Broadcast Products Technical Bulletin 20-2007-195

SUBJECT: CAMERA DOES NOT SWITCH FROM STANDBY
TO MAIN AT POWER-ON

MODEL: **HDC1000/LB**
HDC1000/LW
HDC1000/LW
HDC1000/LW1
HDC1000/LW2
HDC1500//UL
HDC1500/L
HDC1500/L
HDC1500/L1
HDC1500/L2
HDC1580/L
HDC1580/L1

Figure 1

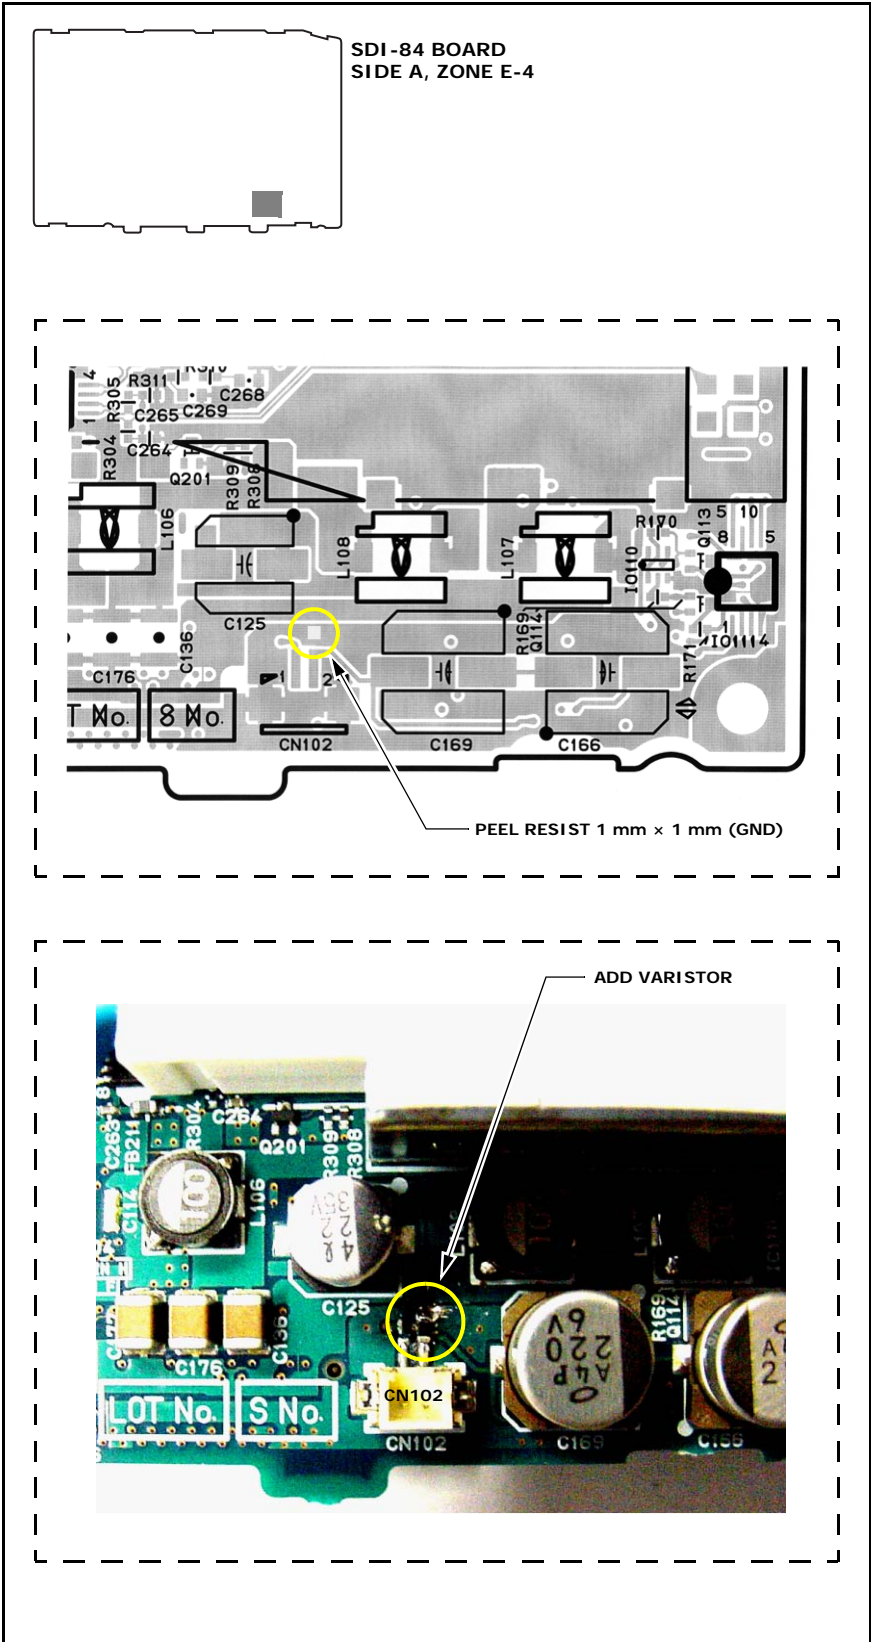
On rare occasions, the camera may not switch from Standby to Main when CAM POWER is turned ON. This symptom may occur if external noise (such as a surge) interferes with the transmission cable between the camera and CCU, resulting in damage to IC110 and IC113 on the SDI-84 board.

1. Remove D111 (side B, zone F-4).
2. Use a utility knife to peel resist near CN102 pin 2 (side A, zone E-4) the size of 1 mm × 1 mm to create a GND area. (See Figure 1.)
3. Solder a varistor between CN102 pin 2 and GND. (See Figure 1.)
